## **Lester Park Golf Course- Clubhouse**

Lester Golf Course Clubhouse

Accessibility Review

**Photo 1:** View of parking. Restripe the accessible parking to provide 8' wide space with an 8' wide aisle (can be shared between 2 spaces).

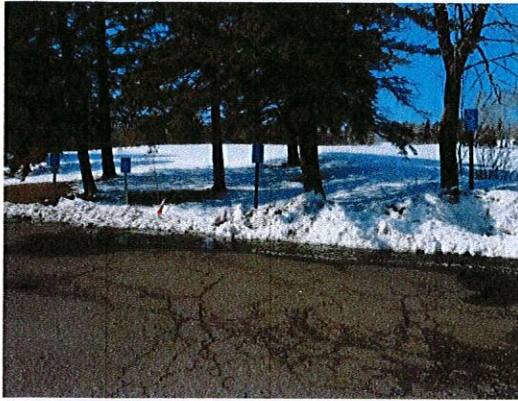
Location JQP # / Item #	Solution / Comments	Qty	Unit Cost	Total Cost	Priority	Estimated Compl. Date	Person Responsible	Actual Compl. Date	Actual Cost
<b>Parking</b>									
05H 16595	Stripe to provide an accessible parking stall that is 8' wide with an adjacent 8' access aisle. It is preferred that the access aisle be located on the passenger side of the vehicle. MN 1341 502.4.2 <i>There are currently signs designating 4 spaces as accessible, the spaces and aisles are not striped. Photo 1.</i>	1	\$150	\$150	3				
<b>Patio</b>									
12H 16583	Bevel / replace / reset threshold so there is no abrupt rise greater than 1/2" or slope greater than 1:2. ICC / ANSI 404.2.4 <i>There is currently at 3" rise at the threshold to the patio. Photo 3.</i>	1	\$200	\$200	3				
<b>Pro Shop</b>									
21A1 16581	Lower a minimum 36" wide section of counter to a maximum height of 36" above the floor. ICC ANSI 904.3 <i>Currently at 38 1/2".</i>	1	\$1,000	\$1,000	3

**Photo 5:** Relocate the computer used to register league and handicap to an accessible location. Currently at 37 1/2".

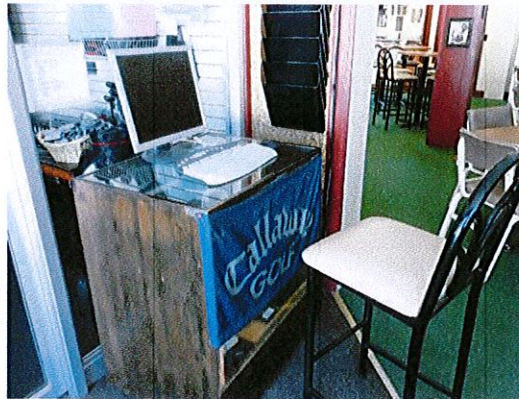
Location JQP # / Item #	Solution / Comments	Qty	Unit Cost	Total Cost	Priority	Estimated Compl. Date	Person Responsible	Actual Compl. Date	Actual Cost
<b>Building Wide</b>									
20D 16577	Provide door hardware that does not require grasping, pinching or twisting to operate, such as lever. ICC / ANSI 404.2.6	4	\$250	\$1,000	3				
40B 16578	Provide compliant raised and Braille permanent room identification signage. MN 1341 1110.2	4	\$40	\$160	3				
				<i>Location Subtotal:</i>					\$1,160
<b>Computer Station</b>									
29A 16582	Provide a minimum of one computer lab on an accessible permanent or movable table / counter. The top height of the surface is to be 28"-34" above the floor, with knee clearance a minimum 27" high by 30" wide x 19" deep. ICC / ANSI 902.2 <i>The computer for registering league and handicap is currently at 37 1/2". Photo 5.</i>	1	\$200	\$200	3				
<b>Lower Level</b>
